SUBJECT: Indian Point Nuclear Generating Units No. 2 and No. 3
Docket No. 50-247, and 50-286
**Reply to RAI regarding Relief Requests to Use ASME Code Case N-613-1;
Reactor Vessel Nozzle-to-Vessel Weld Inspections (TAC MC1698 & MC1699)**

**RESPONSE TO REQUEST FOR ADDITIONAL INFORMATION REGARDING
REQUEST FOR RELIEF TO USE ASME CODE CASE N-613-1**

**ENTERGY NUCLEAR OPERATIONS, INC
INDIAN POINT NUCLEAR GENERATING UNIT NO. 2 AND 3
DOCKETS 50-247 AND 50-286**

**INDIAN POINT NUCLEAR GENERATING UNIT NO. 2
THIRD TEN-YEAR INTERVAL INSERVICE INSPECTION PROGRAM
RELIEF REQUEST RR-67, Rev. 1**

RPV OUTLET NOZZLE

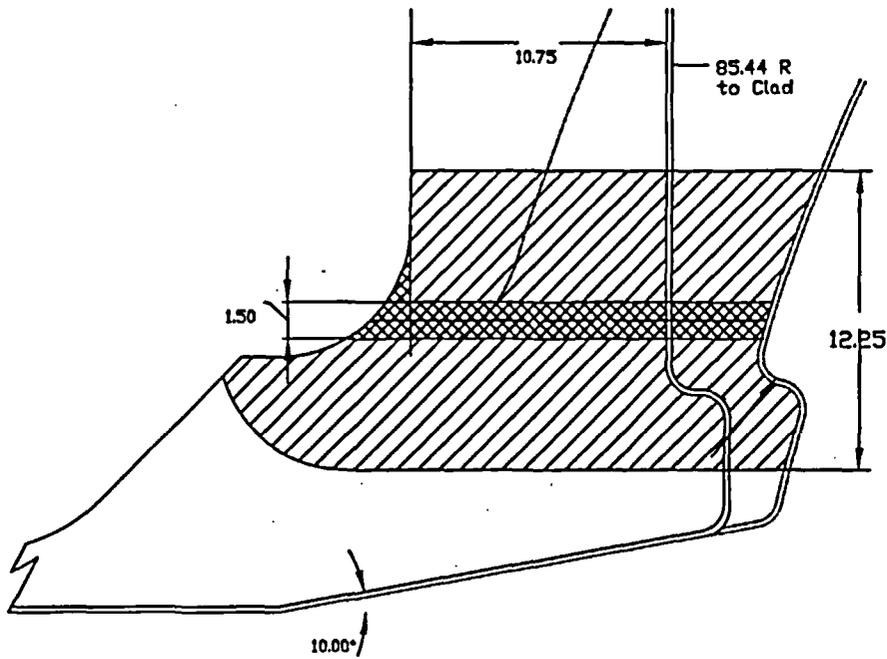
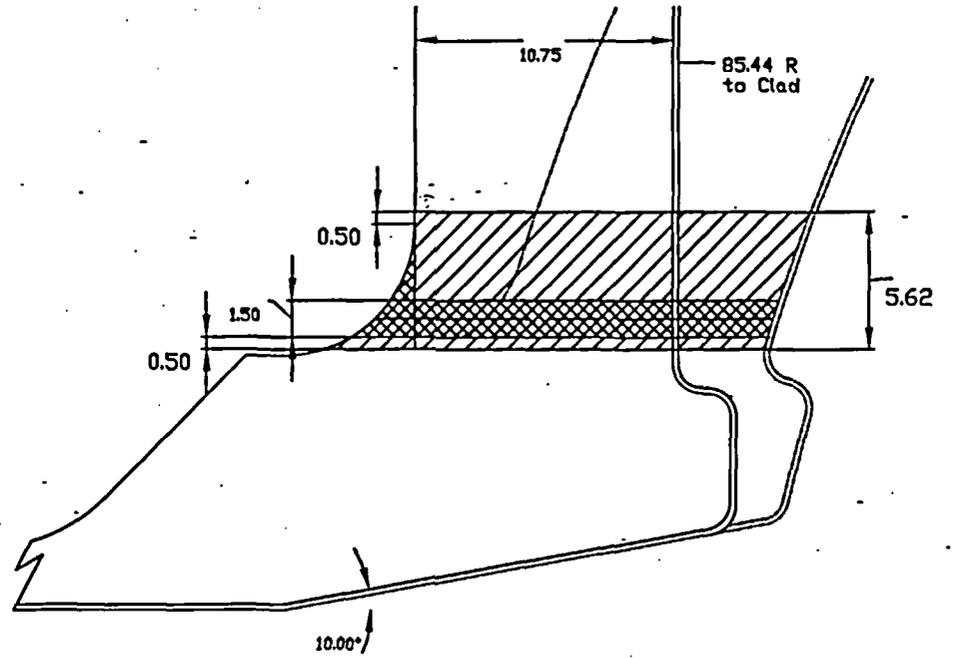
The weld sketches shown on the "Wesdyne" sketches (Attachment 2 to the December 30 letter) are idealized drawings, which infer that the welds were square butt welds and welded perfectly. Since the welds to be examined are not ideal, perfect welds, it is unclear how the licensee will be able to precisely locate the extremities (widest sections) of the nozzle-to-vessel welds. It is unclear how repaired areas (fabrication or inservice) extending beyond the ideal weld cross-sectional area are identified, and how these areas will be examined.

- a. Discuss the documentation available of the actual cross-sectional dimensions and precise locations of repaired areas for all RPV Nozzle-to Vessel welds and IP2 and 3. Discuss the process for defining new examination volumes that encompass the repair areas.*
- b. If examination personnel are to identify the extremities (widest sections) of the nozzle-to-vessel welds, what positive means of examination (such as weld etching) will be used to identify the weld extremities? Will the weld extremities be identified on both the inside and outside diameters of the vessel to ensure complete coverage of the welds?*
- c. Describe the process for accurately determining the location of ultrasonic reflectors with respect to the proposed new examination volumes.*

The examination volume sketches (see WesDyne sketches included with the Relief Requests) duplicate the depiction of the weld nugget as it is shown in the reactor vessel nozzle design detail drawing (CE proprietary drawing E-234-045-1). Indian Point Units 2 and 3 are dimensionally identical in this regard. This is the most reliable source of dimensional data for defining the examination volume.

The weld volume is defined using dimensional data from design drawings as described in response to question 2(a). To ensure the extremities of the weld are included in the examination volume, a margin of 0.5 inches is conservatively added to the scanning path of all transducers in all directions as allowed by component geometry. This is standard practice for nozzle-to-shell, shell welds, and nozzle-to-pipe welds examinations. The WesDyne sketches included in the relief requests have been revised to reflect this additional conservatism.

NOTE: FOR CONSERVATISM, THE SCAN PATH FOR EACH ULTRASONIC TRANSDUCER IS TYPICALLY EXTENDED 0.5' BEYOND THE LIMITS OF THE EXAM VOLUME AS PERMITTED BY GEOMETRY.
